IWG TF-PP3, Discussion on 2/3 and 1/3 HIC Zones

2021-11-30

2010 Kia Forte

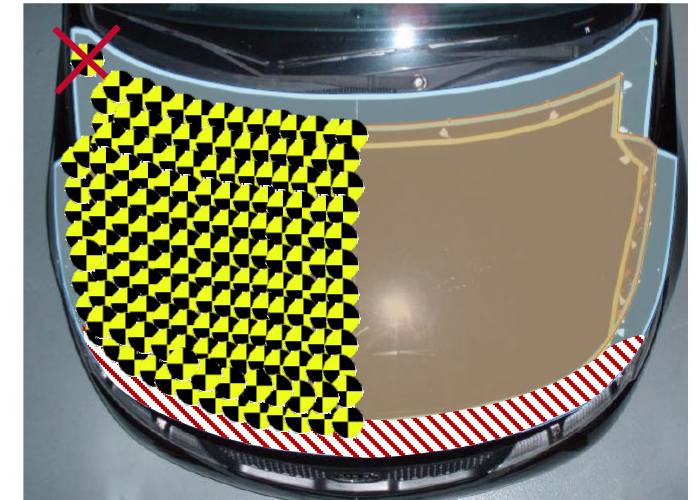
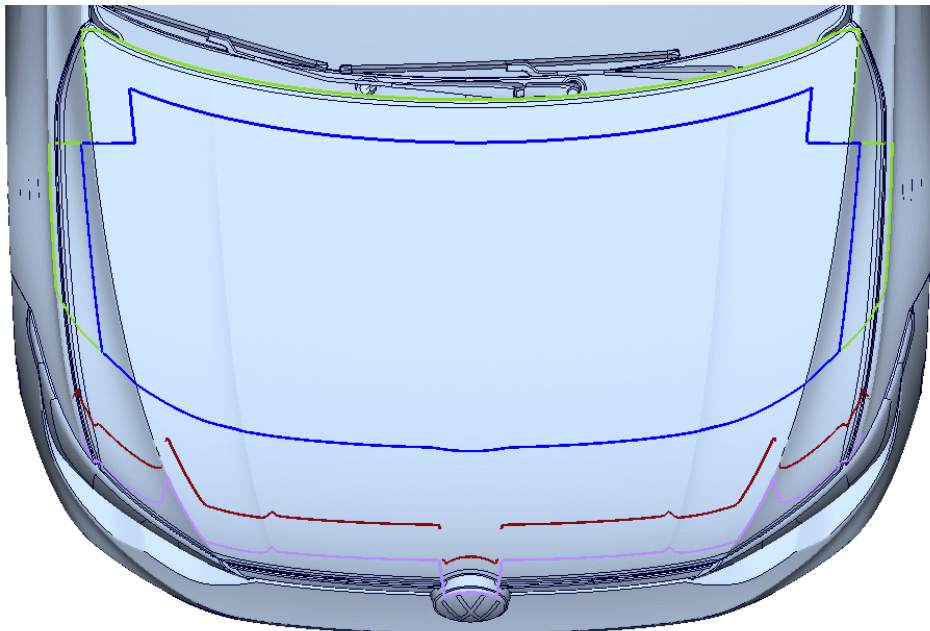
Comment:

The area in front of the WAD1000 is shown in grey but is in fact no zone with an offset of 82.5mm, and shall therefore not be taken into consideration for the percentage calculation of area differences between NHTSA approach and the GTR No.9 amendment.

Bonnet Reference Line -82.5mm Deformation Analysis

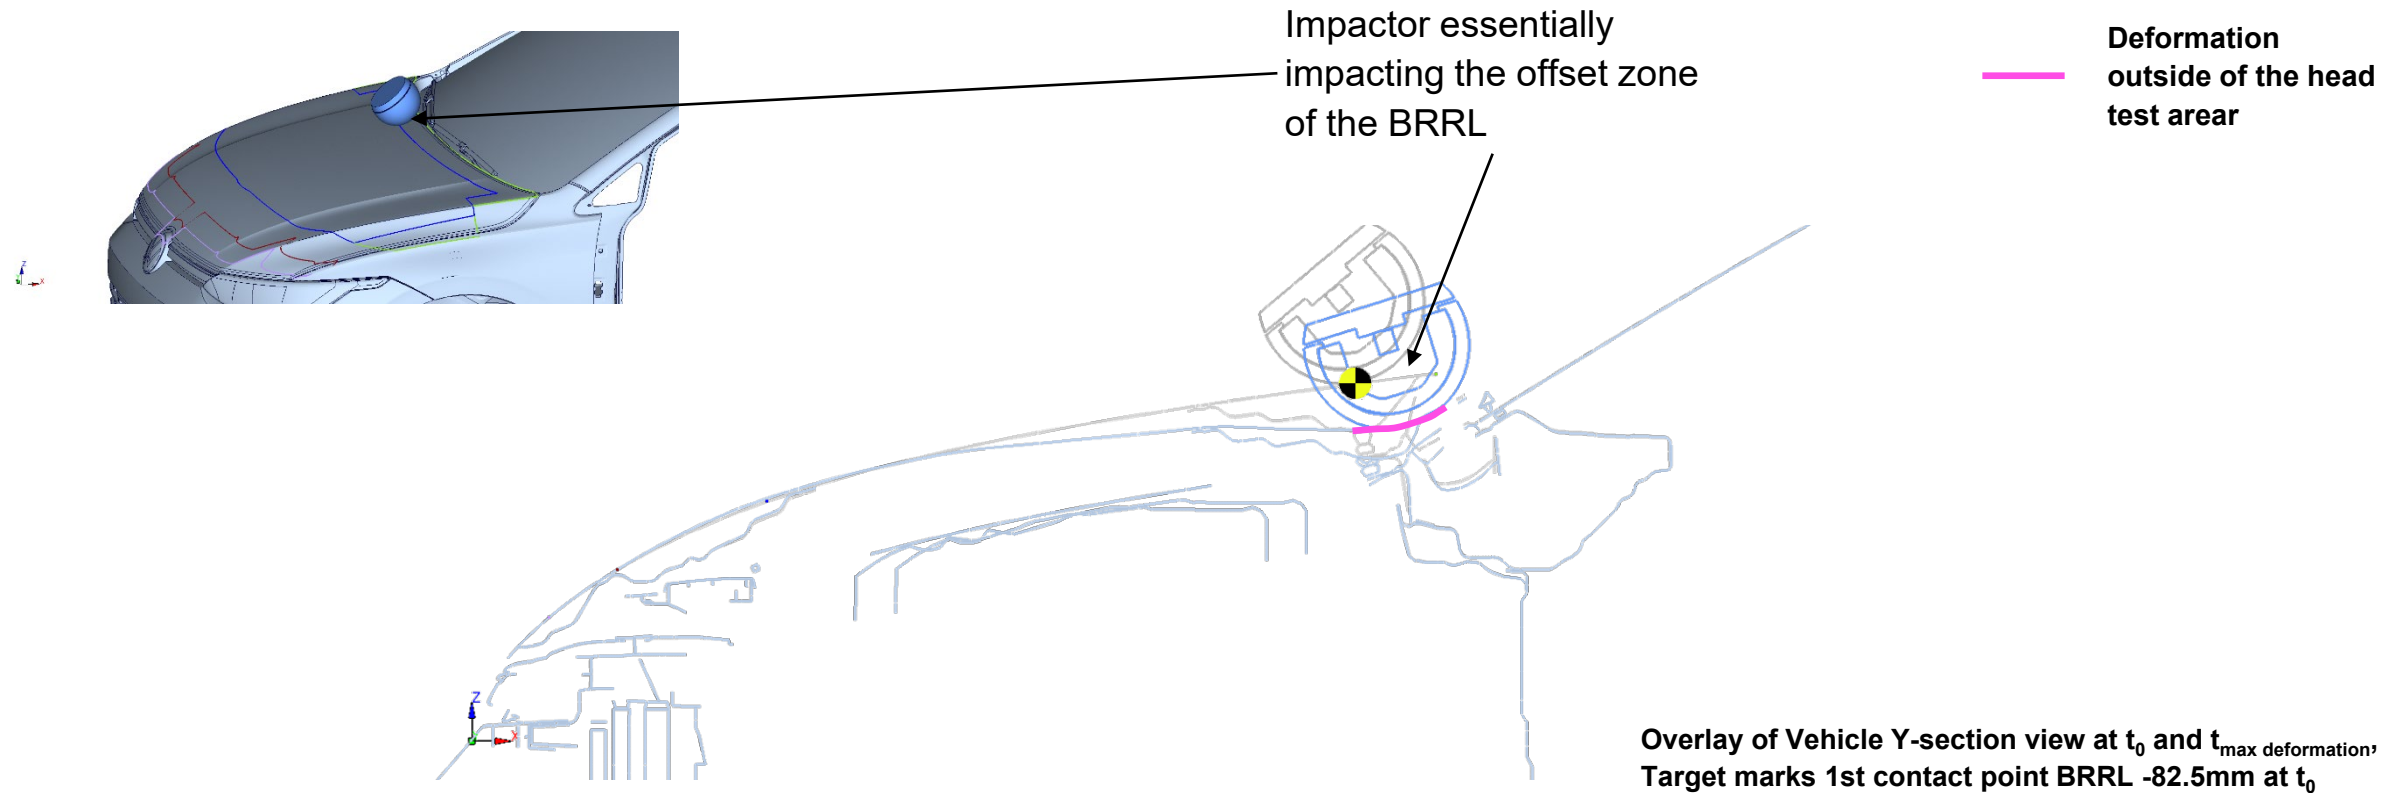
- Large area of deformation in front of and behind BRRL -82.5mm up to end of bonnet
- Significant contribution to low HIC values by vehicle area within the offset zone

WAD1000 Deformation Analysis

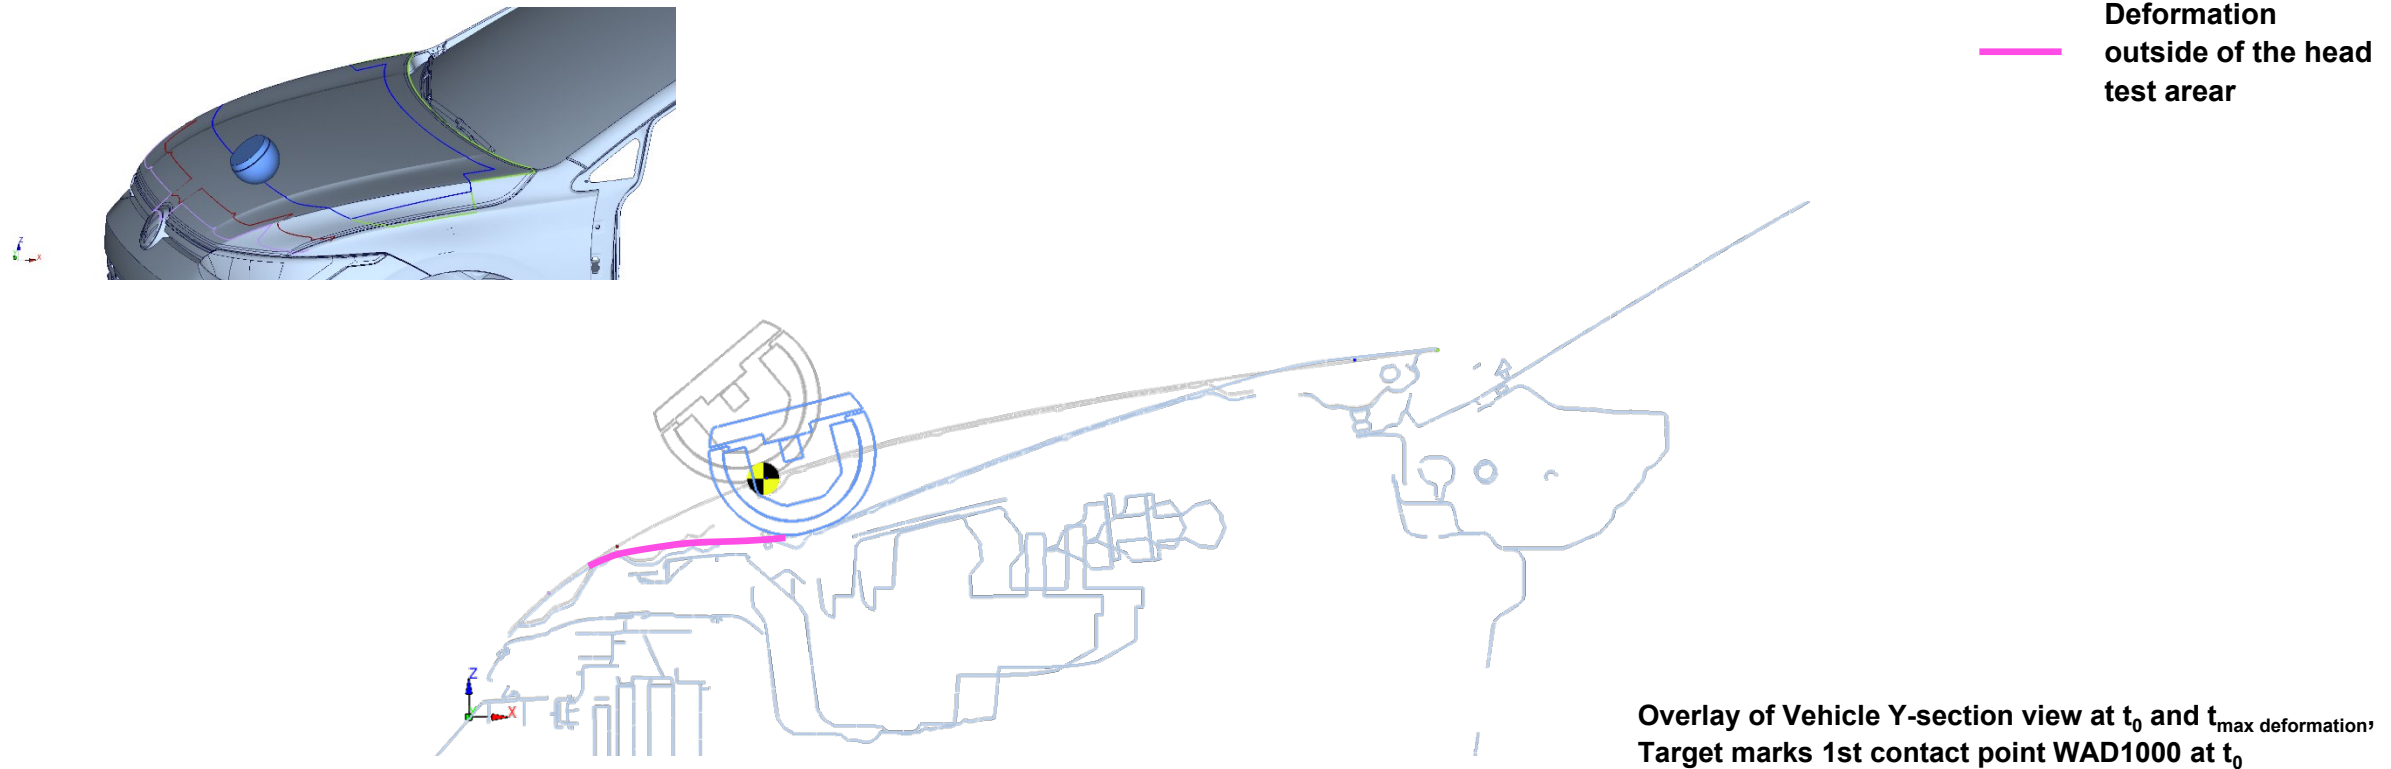
- Large area of deformation in front of WAD1000
- Significant contribution to low HIC values by vehicle area outside of reference lines

Side Reference Line -82.5mm Deformation Analysis

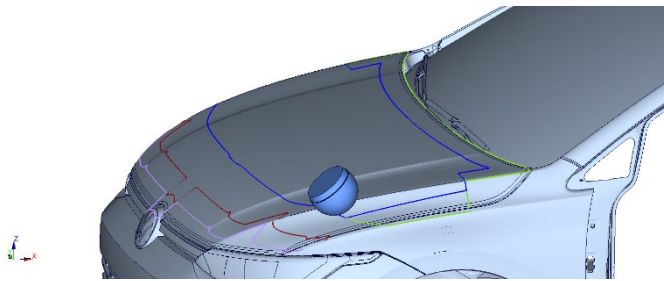
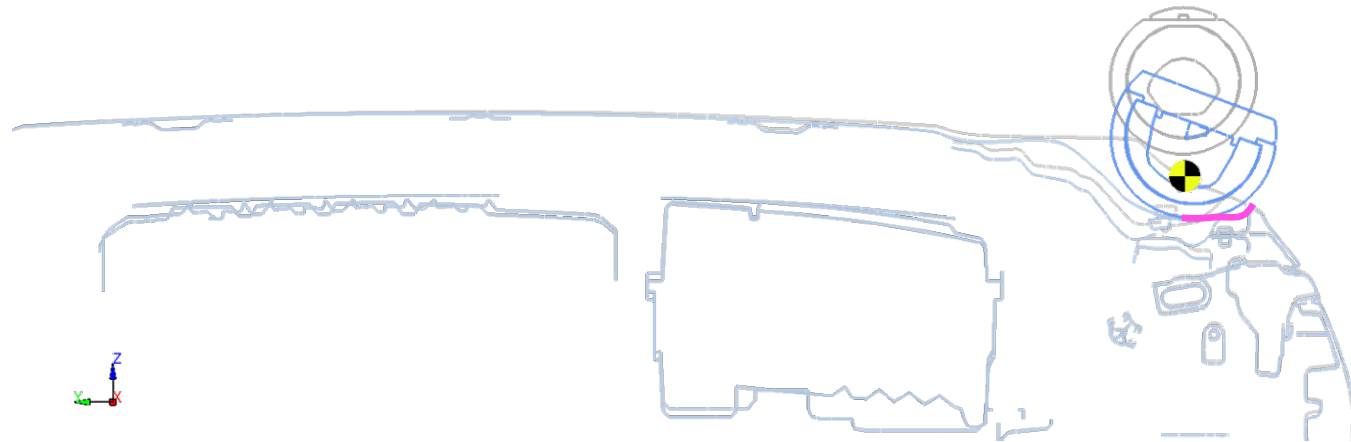
— Deformation
outside of the head
test area

- › Deformation within the offset zone, outside of Side Test Line occurs
- › Contribution to HIC value by deforming area within the offset zone

Bonnet Reference Line -82.5mm Deformation Analysis

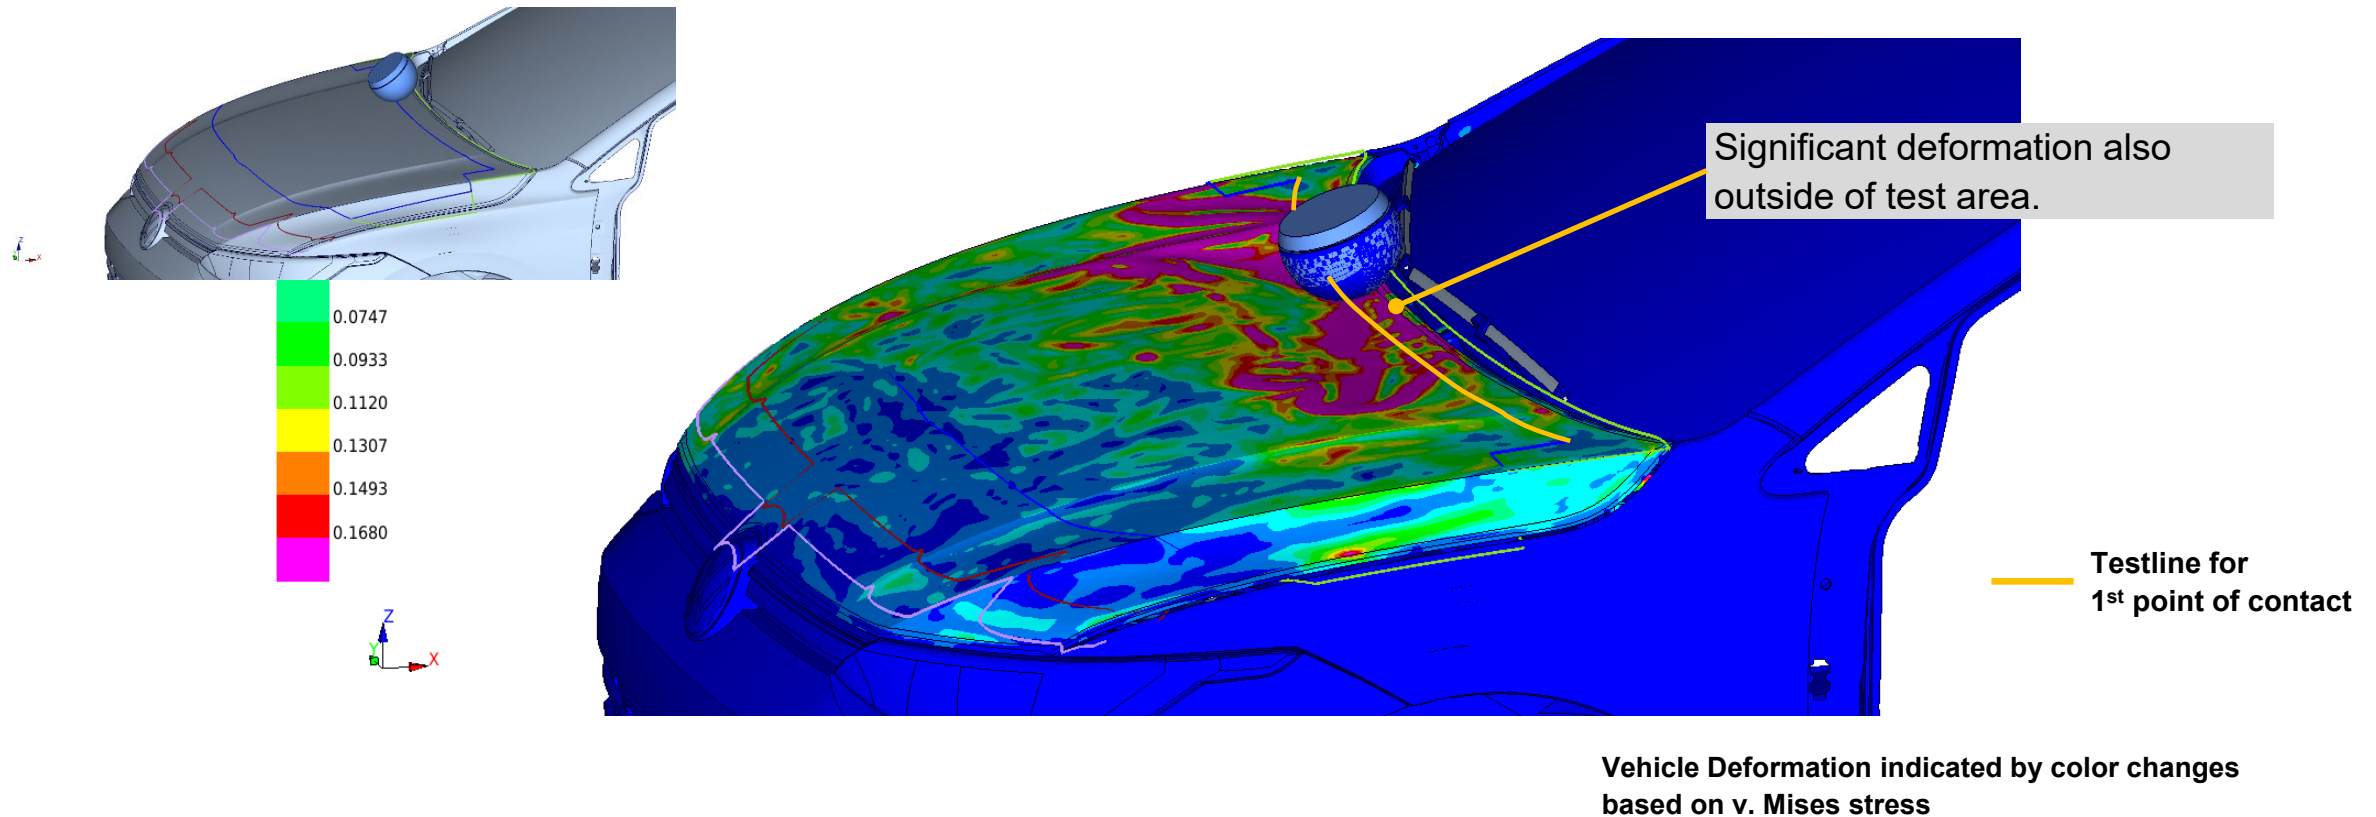
- Large area of deformation in front of and behind BRRL -82.5mm up to end of bonnet
- Significant contribution to low HIC values by vehicle area within the offset zone

WAD1000 Deformation Analysis

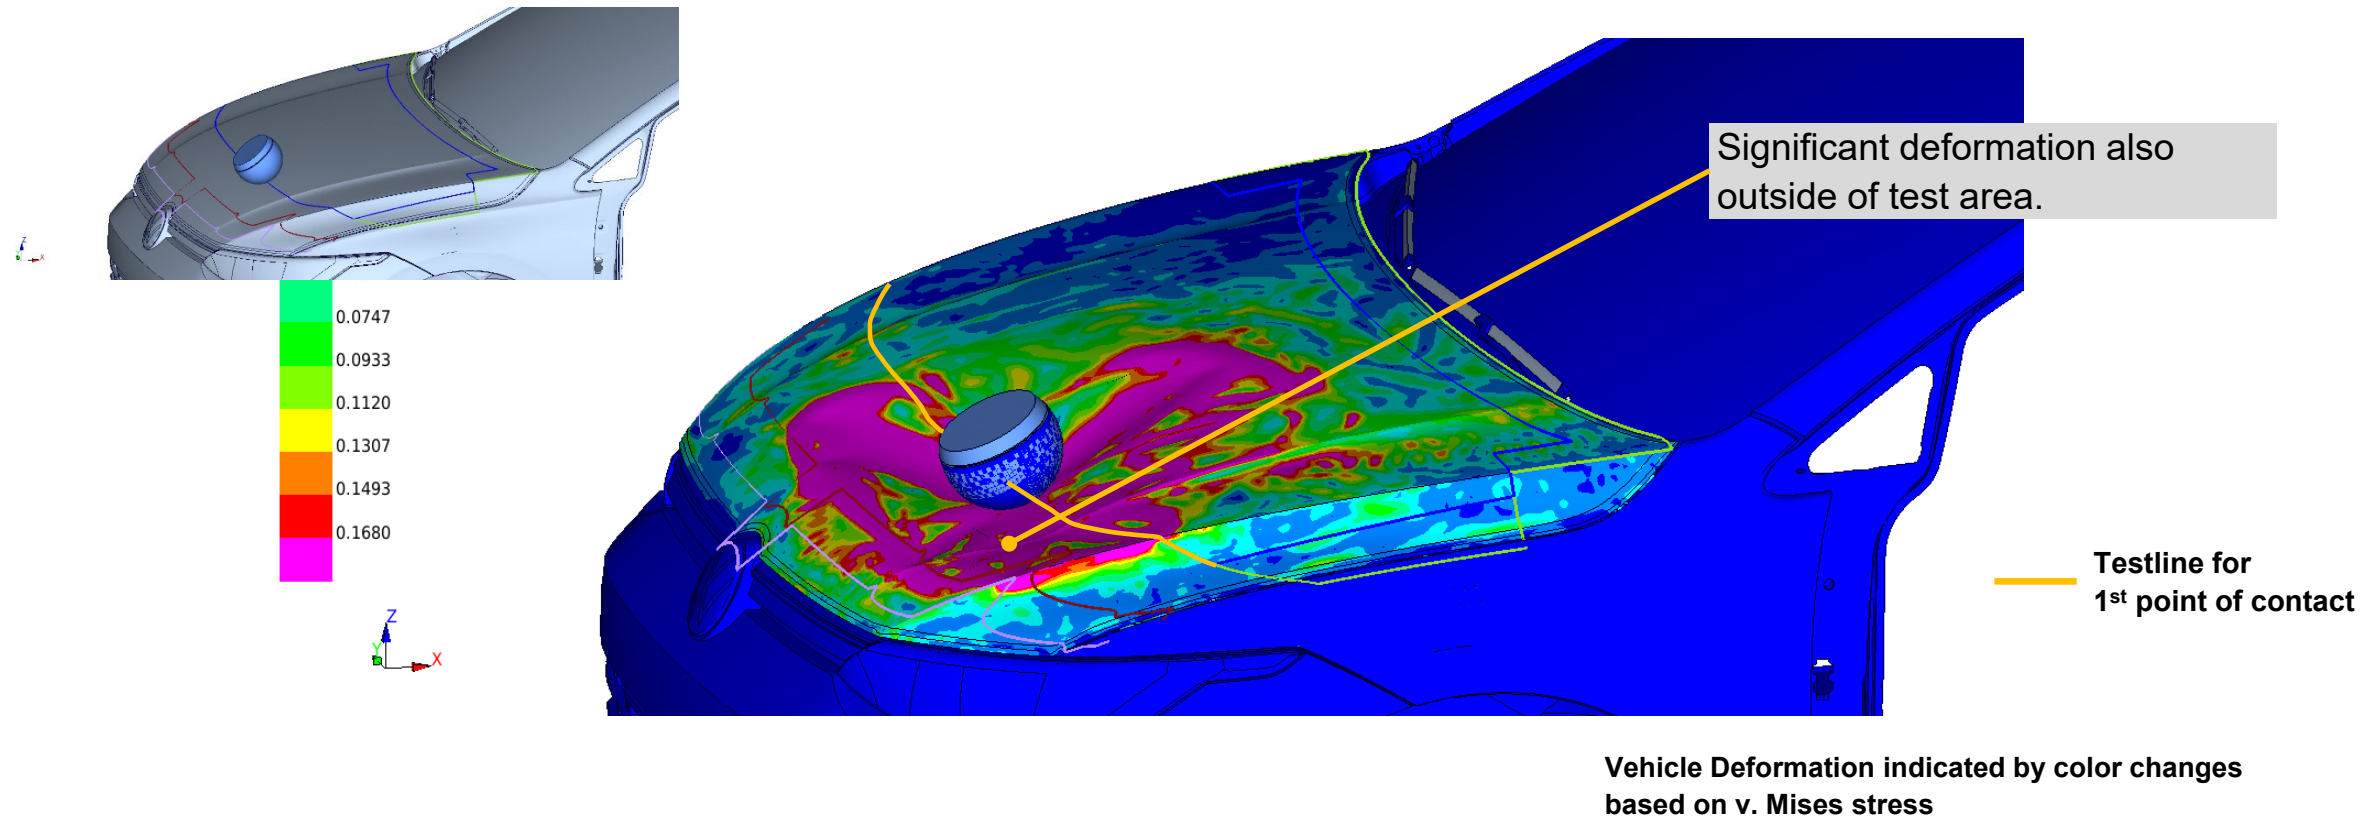
- Large area of deformation around impact point
- Significant contribution to low HIC values by vehicle area outside of reference lines

Side Reference Line -82.5mm Deformation Analysis

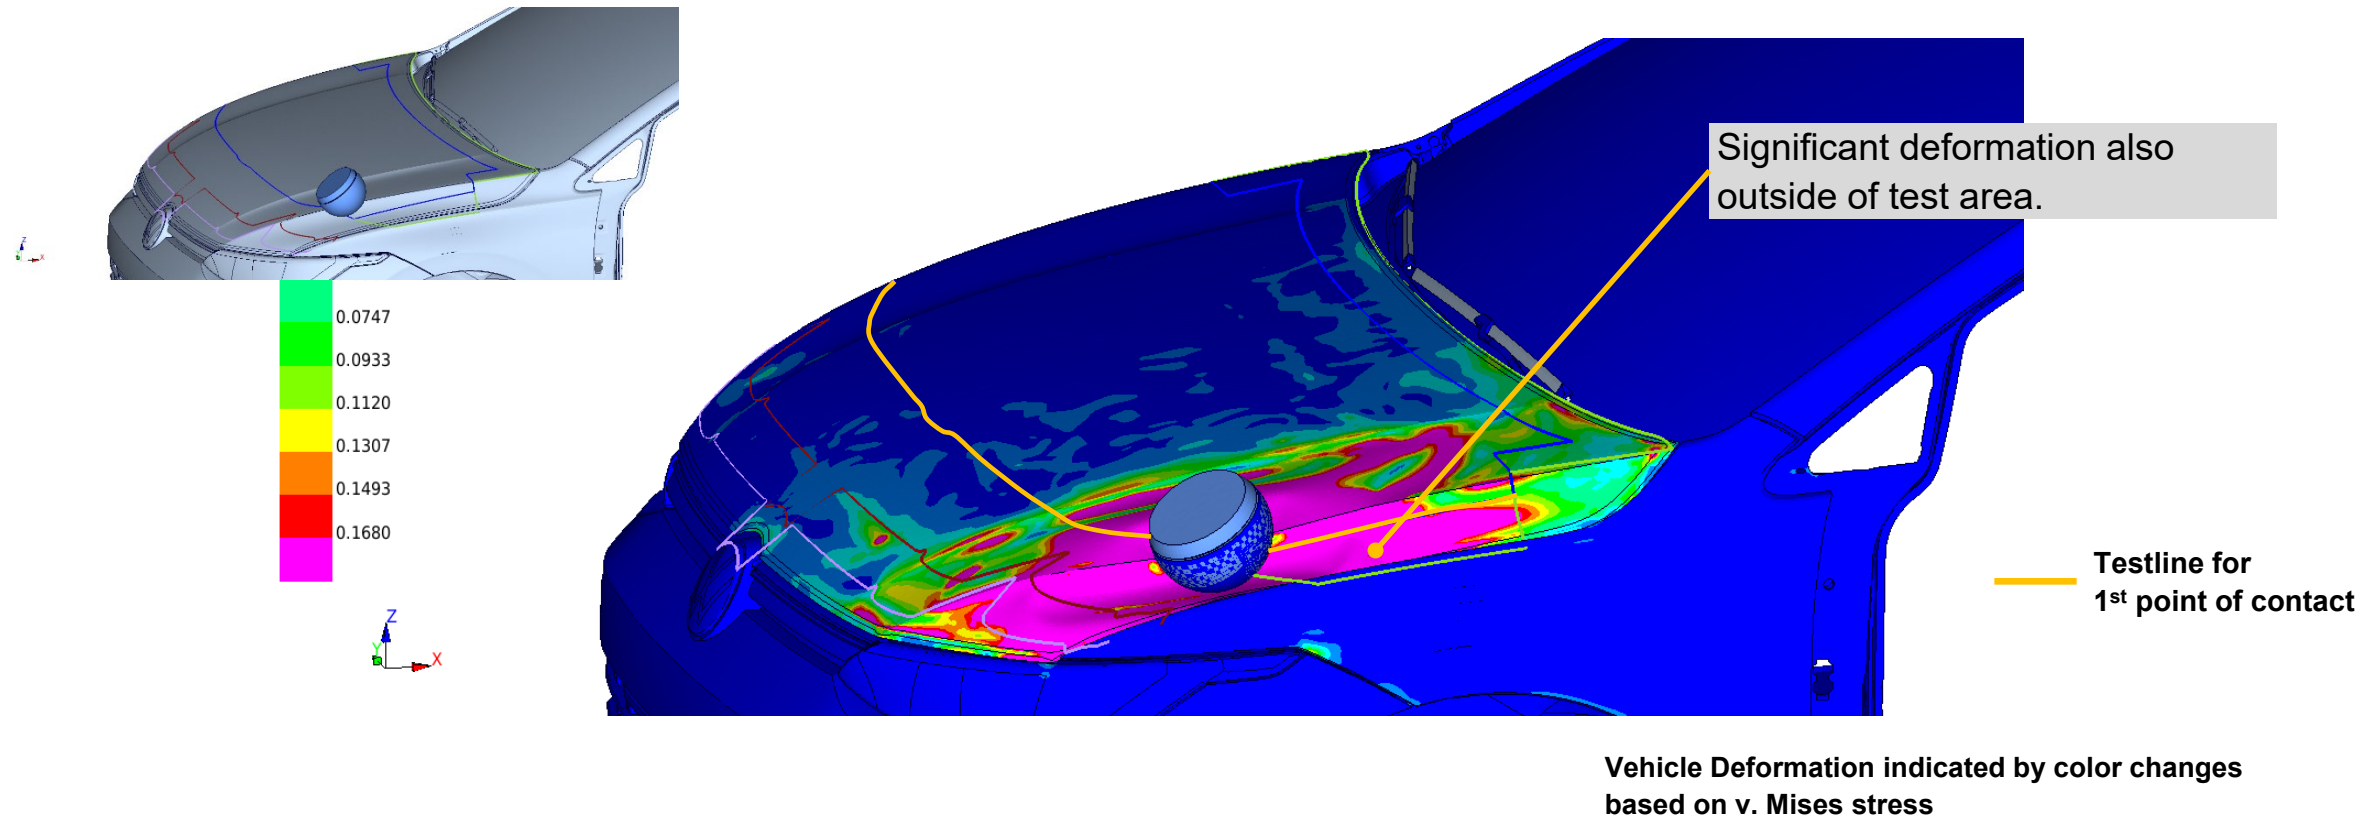
- > Deformation up to SRL occurs by impact on SRL -82.5mm (CoG impactor)
- > Contribution to HIC value by area within the offset zone and in front of test area
